**Title: QUALITY AUDIT (Stage 1)
 INCLUDING ROAD SAFETY AUDIT
 For;
 Glounthaune Phase 2**

Client: AECOM

Report reference: 1137R01Rev 2

Problem Location Plan.

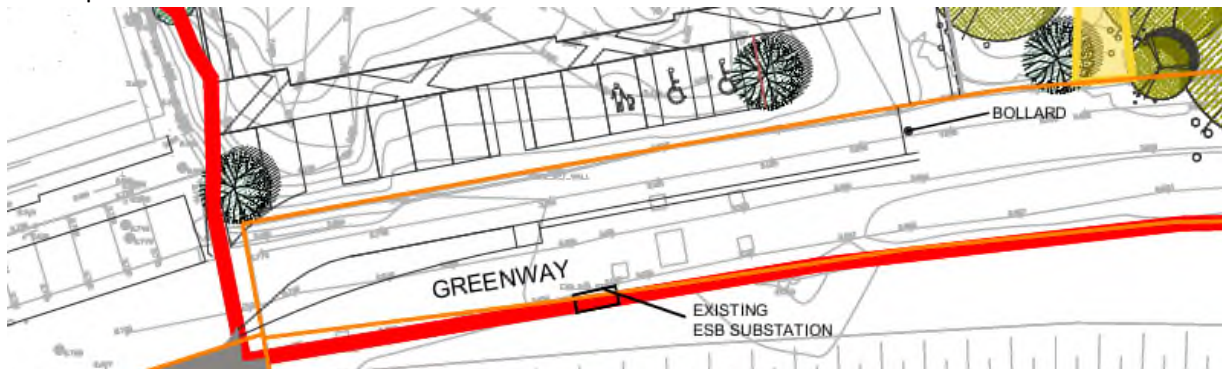
PROBLEM

It is unclear where vehicular traffic stops and the greenway will start at the apartment block (units 266-289). A pedestrian route to the shop from the greenway and from the pedestrian route in the proposed development would both have clear desire lines.

RECOMMENDATION

Ensure that the layout and signage is unambiguous to distinguish routes for vulnerable road users to get to the shop.

3.3	Yes	Yes	<p>The proposed vehicular access and the existing greenway will be separated by landscaped strip and bollards. It is also proposed to incorporate separate material surfacing to provide a visual differentiation to drivers, pedestrians, and cyclists.</p> <p>Way finding signage is proposed as part of the development to guide users/ occupants using the path and greenway. The layout proposed</p>	Yes

Paragraph No. in Quality Audit Report	Problem accepted (yes/no)	Recommended measure accepted (yes/no)	Alternative measures (describe)	Alternative measures accepted by Auditors (Yes/No)
			<p>will tie in with the existing greenway/ footpaths and incorporating crossing locations.</p> <p>A visualization of the proposed layout to the front of the apartment block is included.</p> <p>5.9 Visualisations (G-NET)</p>
